ADDENDUM NO. 1

This addendum includes Item Number 1-1 thru 1-76. This addendum item shall be fully incorporated into the Bidding/Contract Documents and have the same force and effect as though originally included.

Life Sciences Collaboration
1910 N. Antelope Valley Parkway
Lincoln, Nebraska
TCEP No.: 716-002-12
Davis Design.: 12-0077
BVH No.: L12018.unl
November 27, 2013

Item 1-66: Sheet E0.01 – Electrical Site Utilities Plan

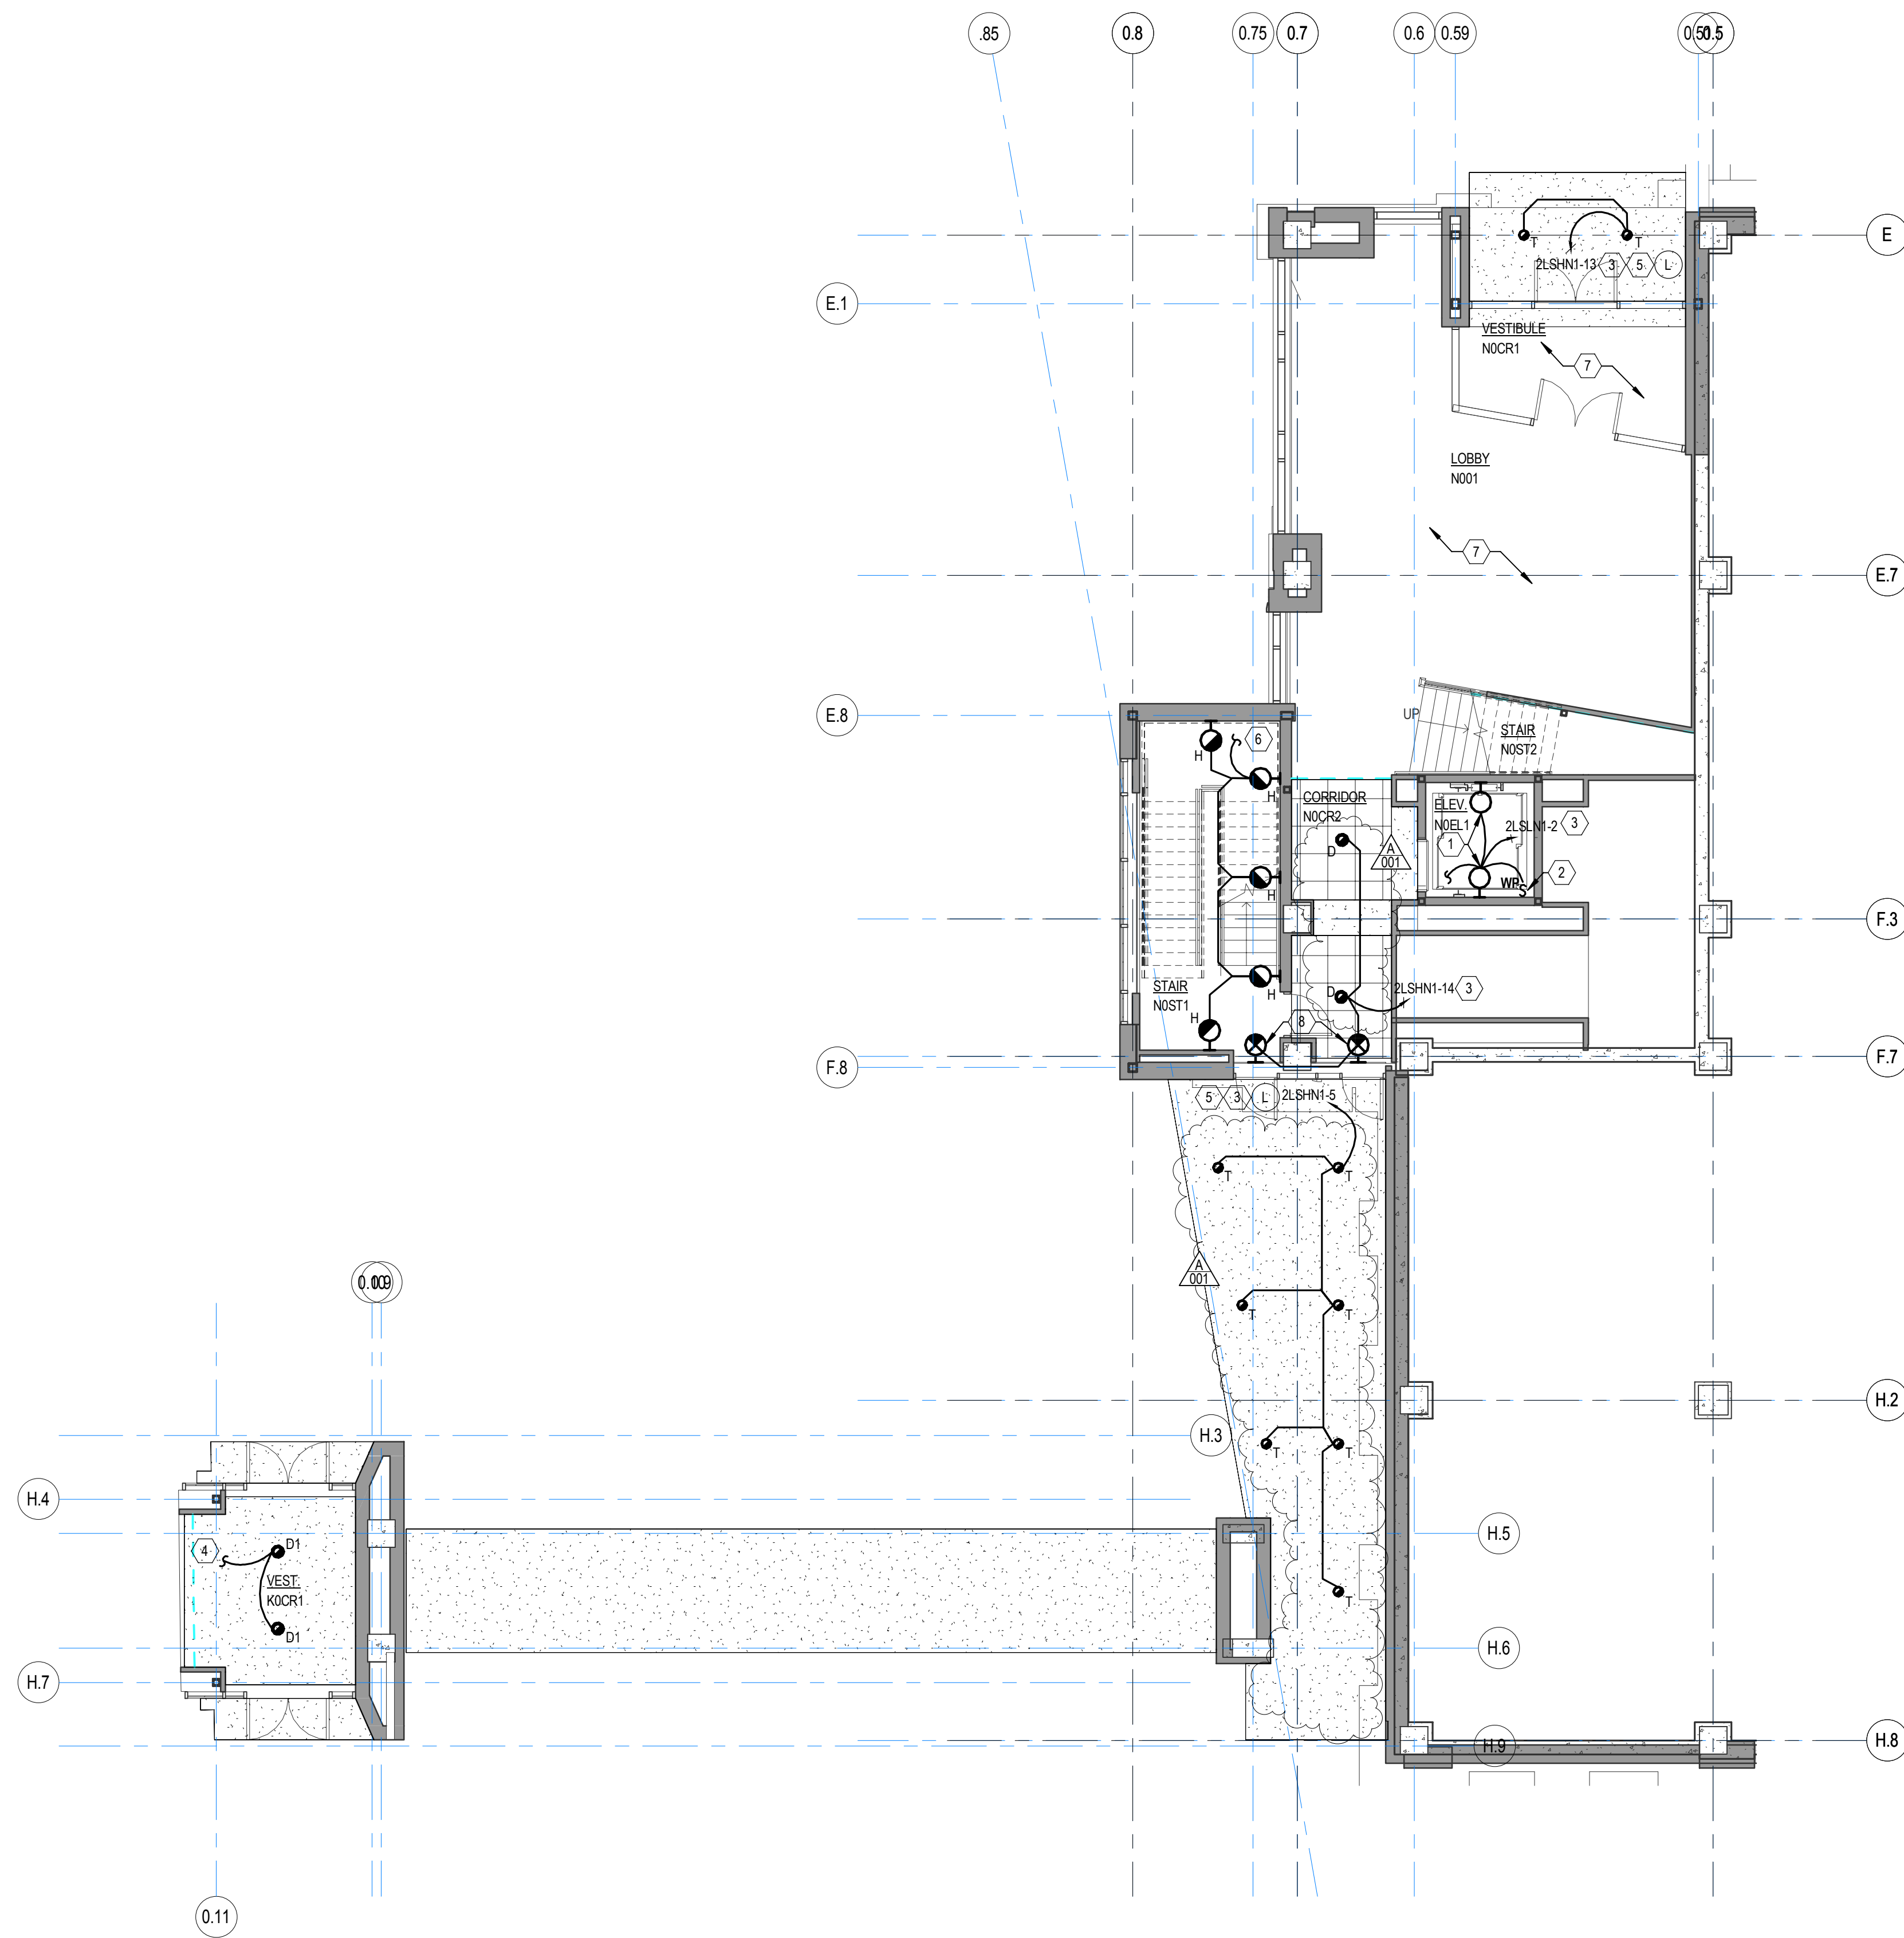
Site lighting and additional details have been modified. This sheet is being re-issued in its entirety as a part of this addendum. See re-issued sheet E0.01 for changes.
